ADDENDUM NO. 1

To: All Plan Holders of Record and Interested Parties
Project: Clinton County Administration Building South Roof Replacement
IIW Project No.: 20036
Issue Date: July 16, 2020
Bids Due: July 28, 2020

R FAM-1 FULLY ADHERED MEMBRANE ROOF OVER EXISTING DECK

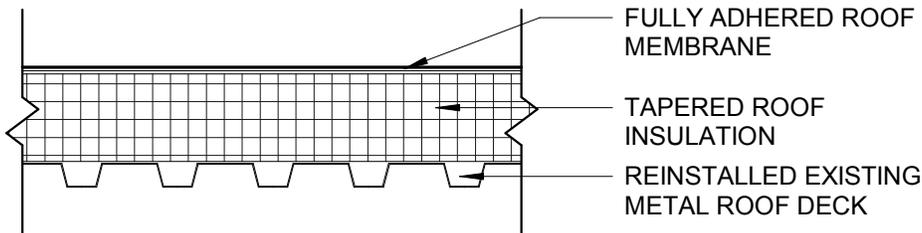
1. SHEET A0.1:
 - a. Replace ROOF SYSTEMS with Addendum Drawing A/AD1-1.
2. SHEET AD1.0
 - a. Demolition Notes:
 - i. Change Note #1 to read: "Remove existing roof ballast and loose laid roof insulation. Existing built up roof membrane layer, sloped lightweight concrete, and all wood blocking to remain on existing poured concrete roof deck"

1. TOTAL ROOF SYSTEM MINIMUM R-VALUE = 30.
2. NEW ROOF INSULATION TO BE MECHANICALLY ATTACHED THROUGH EXISTING SLOPED LIGHTWEIGHT CONCRETE AND INTO EXISTING POURED CONCRETE ROOF DECK.
